HISTORIC AND DESIGN REVIEW COMMISSION

August 04, 2021

HDRC CASE NO: 2021-296
COMMON NAME: Elmira at Myrtle – Lots previously addressed as 1212, 1216 and 1218 E Euclid; 813, 823 and 825 E Myrtle, and 818 E Locust
LEGAL DESCRIPTION: NCB 6792 BLK 4 LOT 28 29, 40 & N 15 FT OF 30
NCB 6792 BLK 4 LOT 7&8 9, 34, 35, & 36
NCB 6792 BLK 4 LOT 32 33, 41, 42 & S 15 FT OF 31
NCB 6792 BLK 4 LOT 19 20 & 21
ZONING: IDZ-3, RIO-2
CITY COUNCIL DIST.: 1
APPLICANT: Cameron Kraus/Gensler
OWNER: Jim Young/SABOT DEVELOPMENT
TYPE OF WORK: Construction of a 10-story mixed use tower
APPLICATION RECEIVED: June 18, 2021
60-DAY REVIEW: Not applicable due to City Council Emergency Orders
CASE MANAGER: Edward Hall

The applicant is requesting a Certificate of Appropriateness for approval to construct a 10-story, mixed use structure to feature 229 residential units and first floor retail. The applicant has noted structured, on-site parking for both residential and retail uses. The proposed new construction is located on the lots bounded by E Euclid, E Myrtle, E Elmira, and E Locust; however, it excludes the lots at the corner of E Myrtle and E Elmira. The proposed new construction is located within RIO-2 and will

LIGHTING PLAN - LEVEL 1

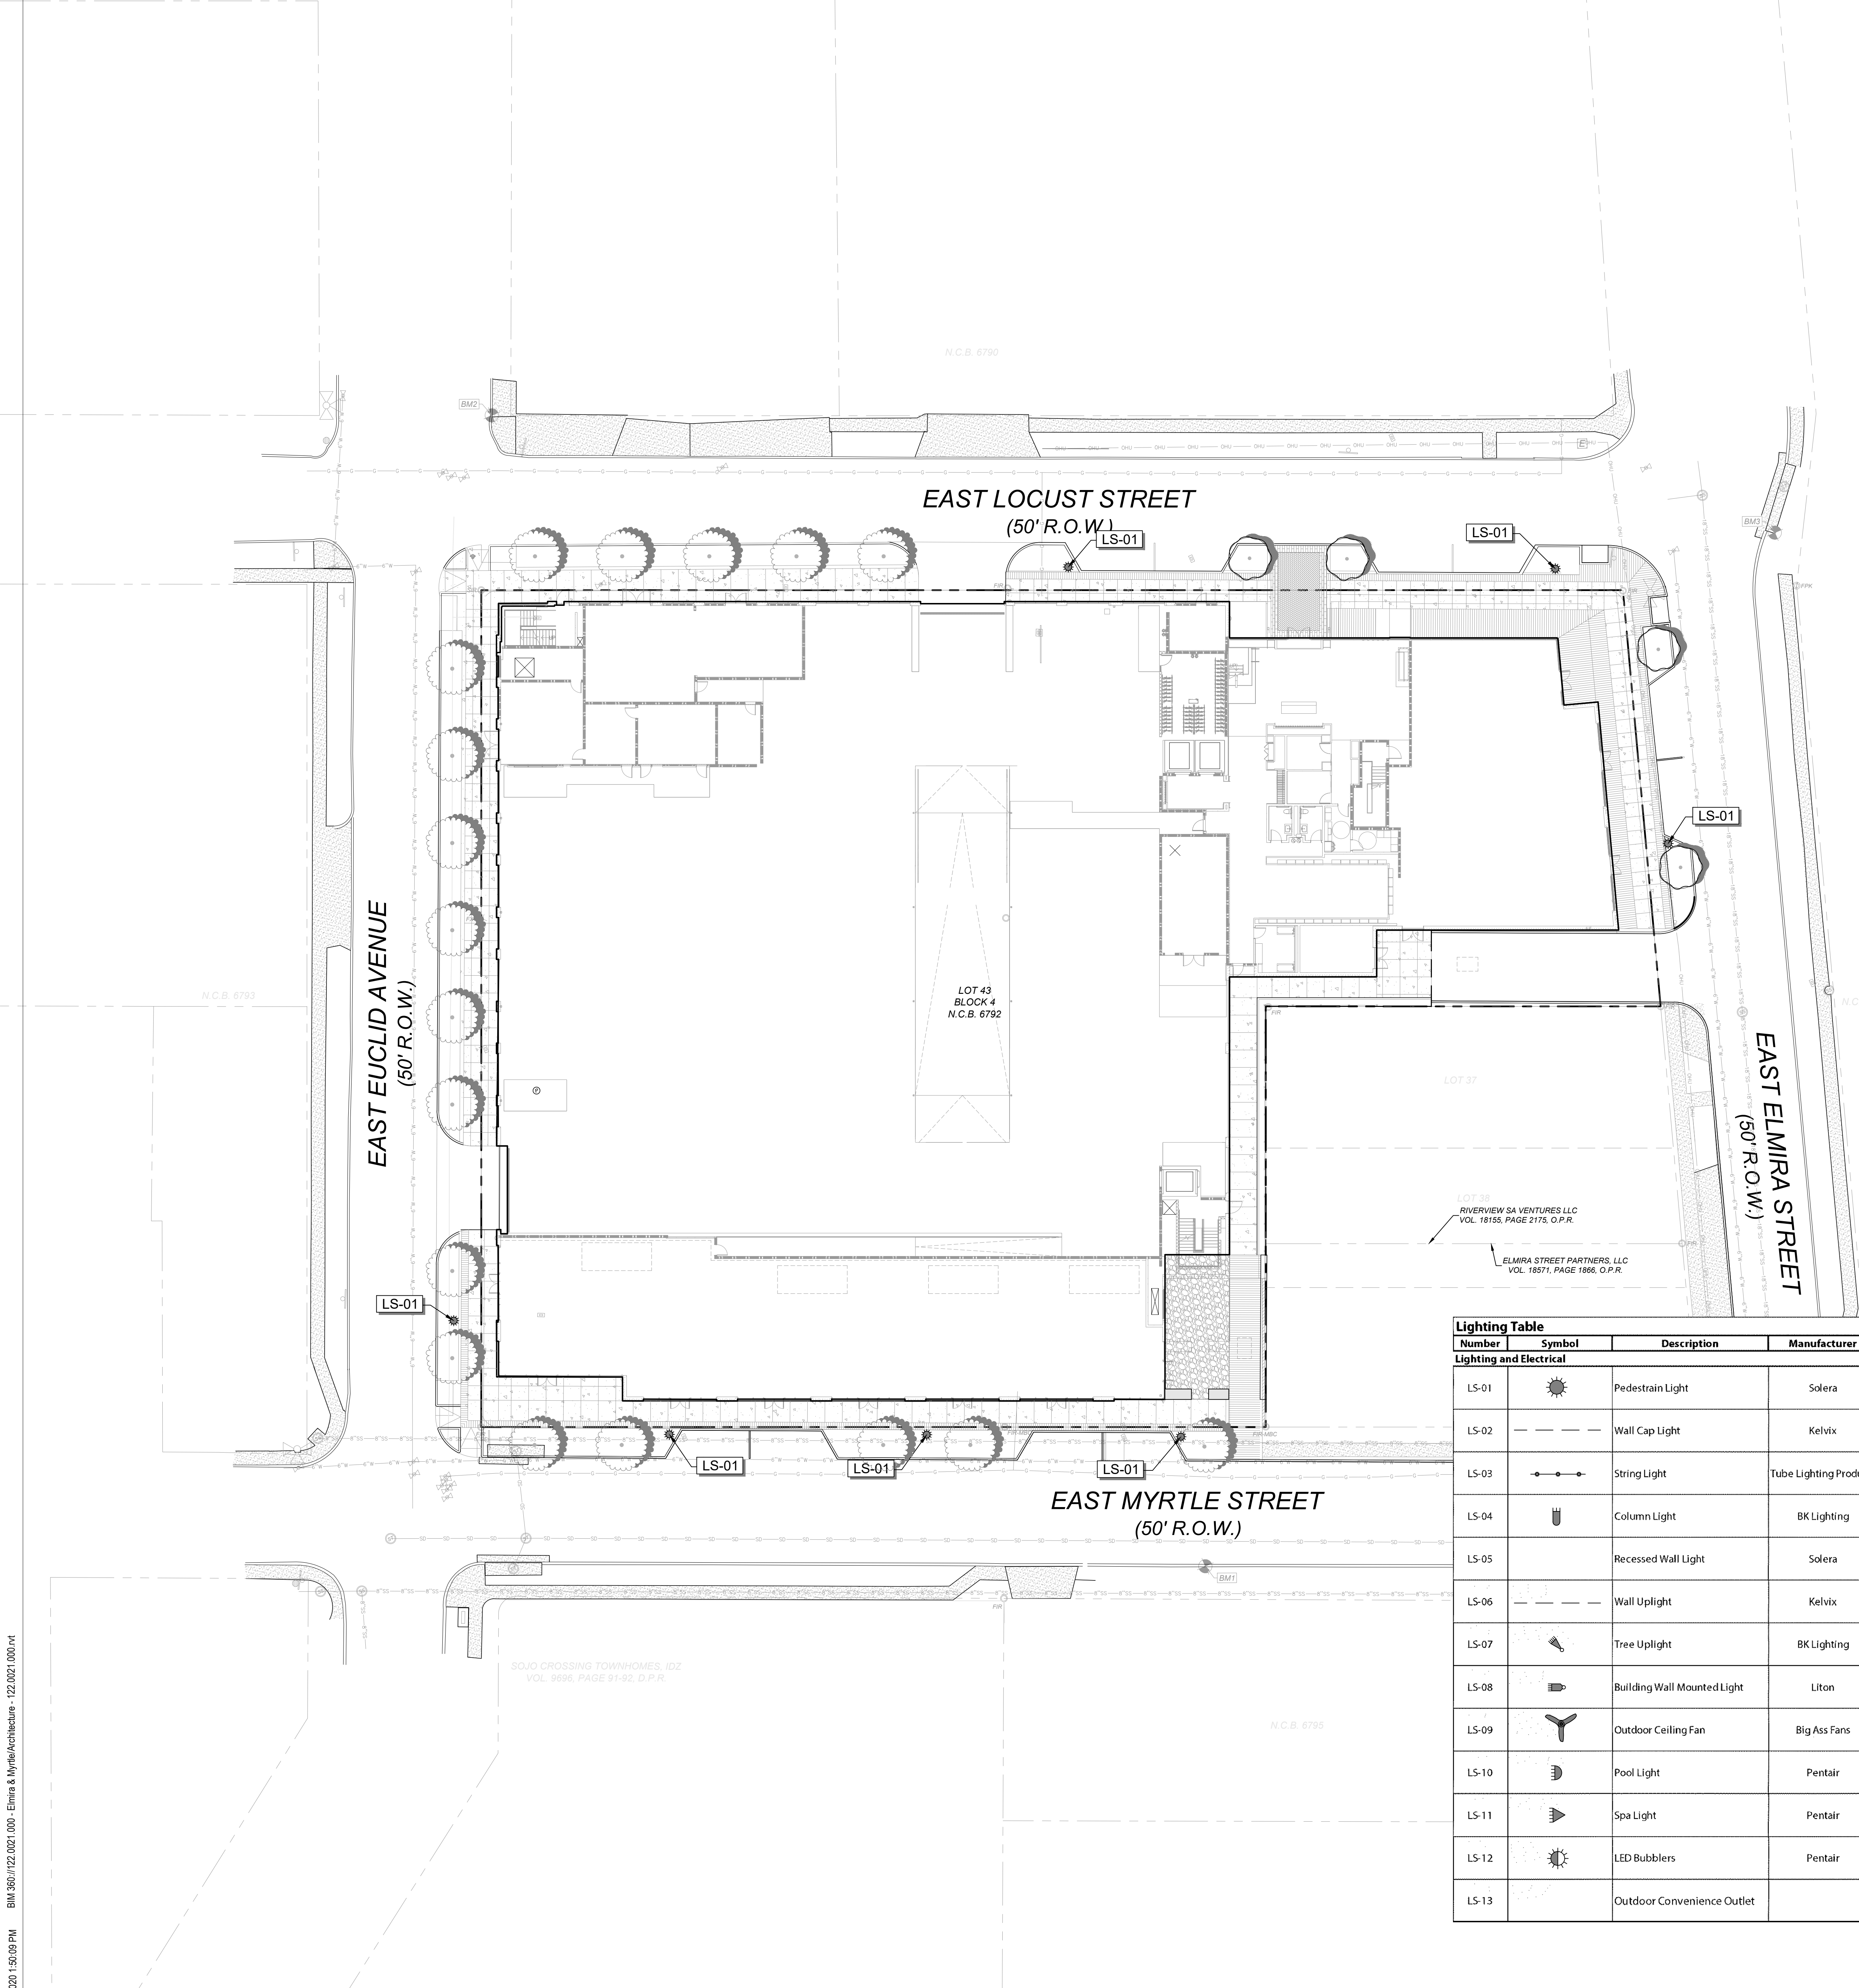
- viii. That the applicant submit a detailed lighting plan when returning to the Commission for final approval. **The applicant has submitted a street and site lighting plan.**
